December 11, 2019

RE: JD 24 Improvements and Final Engineer's Report Independent Review

Figure 1. Clip of Proposed WASCOB and Relative Location of Existing Tile (yellow) from Final Engineer's Report

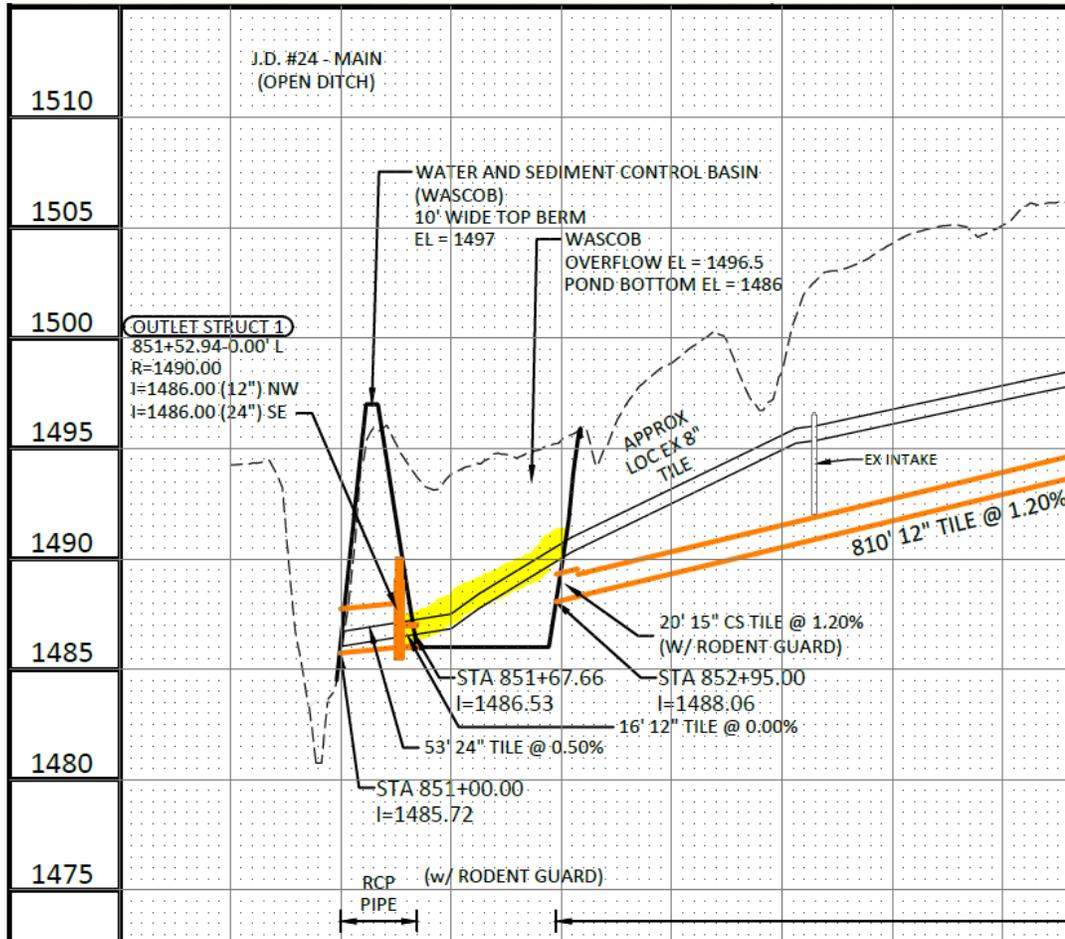
First, we reviewed the proposed plans for WASCOB B included in the 2018 Final Engineer's Report, Sheet 3.01 which shows the profile of the existing drain tile and the proposed grading for WASCOB B. Based on this profile, the existing tile is incompatible with

the proposed WASCOB as it is between 1- and 4-ft above the bottom of the WASCOB, as shown in Figure 1. The existing drain tile cannot remain in place as-is if the WASCOB is constructed.

In order to keep WASCOB B, as proposed and required by the MnDNR, the existing tile must either be re-routed around the basin or broken and allowed to discharge directly into the basin. For the purposes of this evaluation, we have assumed the tile would discharge into WASCOB B. While the Drainage Engineer provided their HydroCAD models of the system, we have evaluated Branch B using EPA SWMM in order to evaluate the existing hydraulics in the current Branch B system as well as the impacts caused by the addition of WASCOB B. The resulting watershed flows from the Branch B SWMM model are different from the HydroCAD models due to the greater detail provided, each inlet and each pipe are included in the model to evaluate the effects of WASCOB B on tile capacity.

The most obvious change is the reduction in peak flow capacity in the mainline Branch B tile. Landowners on Branch B will experience reduced capacity along the mainline Branch B due to the WASC OB affecting the tile outlet hydraulics. The proposed design from the 2018 Final Engineers Report would result in a reduction of approximately 14% of the peak tile capacity. The alternative of combining the proposed WASC OB B with the existing tile worsens the mainline Branch B capacity, causing a reduction of 63% in the peak tile capacity from existing conditions.

Figure 2. FEMA 100-Year Floodplain (FIRM Panel 2706320025B) with Proposed WASCOB (yellow star) and JD24 Outlet (Blue circle)

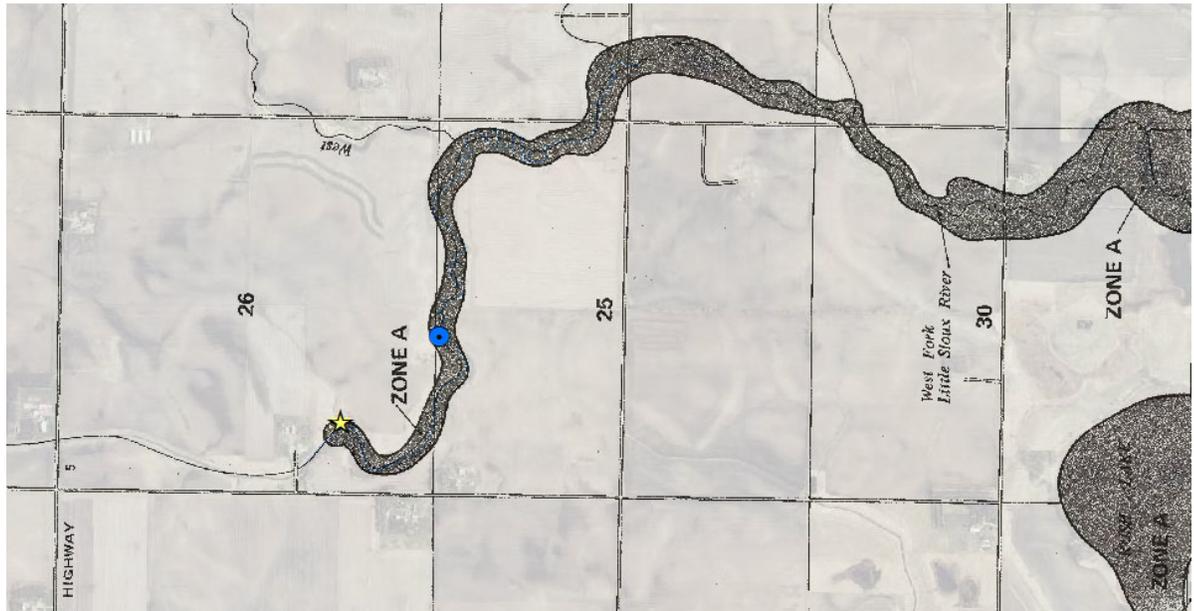
The JD24 system is mapped within the FEMA Special Flood Hazard Area Zone A (AKA the 100-year floodplain) of the West Fork Little Sioux River (Figure 2). Because the proposed improvements are not only altering the hydrology, but also the existing landscape with WASCOB B, we have evaluated the hydraulics at the JD24 outfall using HEC-RAS. Using the HydroCAD flows, modified to include the 100-year event, we developed a HEC-RAS model to evaluate the changes at the outfall due to the proposed improvements. The flows are provided in Table 6 below, taken from the outflow at HydroCAD Node 62R, it should be noted that the HydroCAD models became unstable when analyzing the 100-year event due to high water elevations. In particular, Node 59P (330th Ave) has a higher outflow (2,172 cfs) than inflow (1,355 cfs), indicating the model is unable to balance and the HydroCAD results may be invalid. It is recommended that the model be reviewed to increase storage and reduce these instabilities.

The results from the HEC-RAS analysis indicate that the JD24 outfall would experience an increase in water surface elevation of approximately 0.1-foot due to the proposed improvements upstream. At WASCOB B, there is a maximum increase of 0.33-ft due to changes in grading near the JD24 channel.

At the September 23, 2019 Continued Final Public Hearing, there was concern from residents of Sioux Valley Township that this project would increase the flows entering the West Fork Little Sioux River and exacerbate existing flooding concerns. The HydroCAD and HEC-RAS analyses both confirm that additional water would be sent downstream should this project be implemented.

Figure 3. Location of proposed JD24 Improvements (yellow) and National Wetland Inventory wetlands (green)

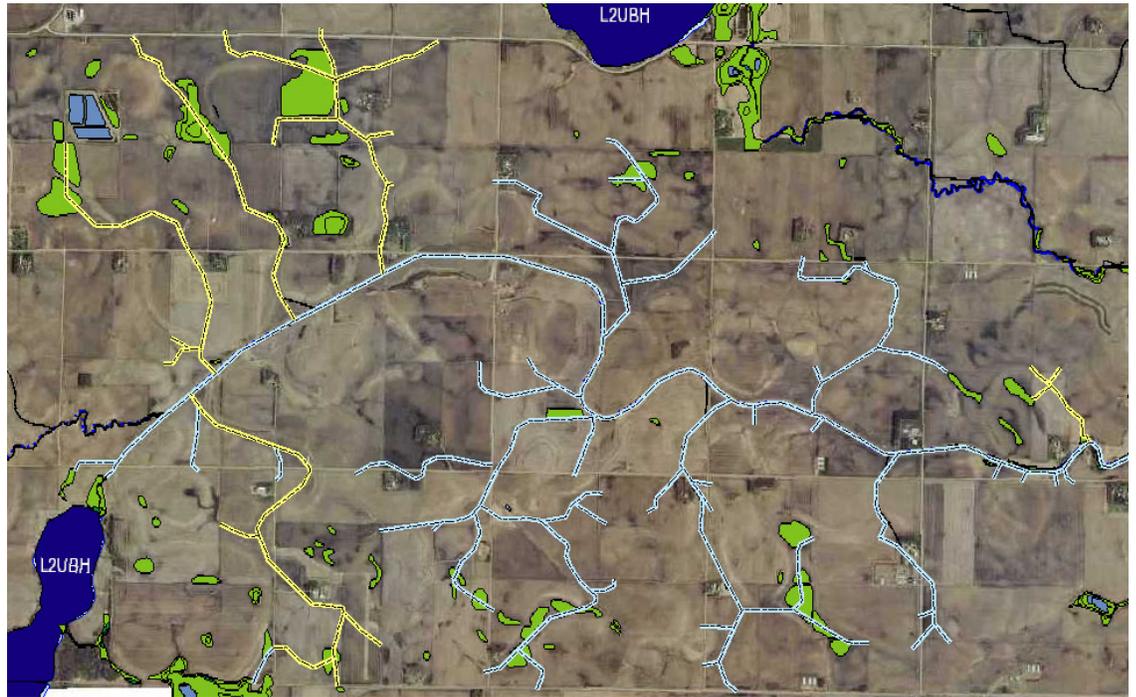
The proposed JD24 improvements will impact 12 wetlands, in particular the wetland at the outfall of Branch B, where the proposed WASCOB B will be located. This wetland will be filled and the hydrology altered, making it likely that the County would need to purchase replacement credits from nearby wetland bank at a cost of roughly \$35,000 per acre of wetland credit. With a 2:1 replacement ratio, this single impact could cost over \$50,000, including the state-required withdrawal fee of \$4,000.
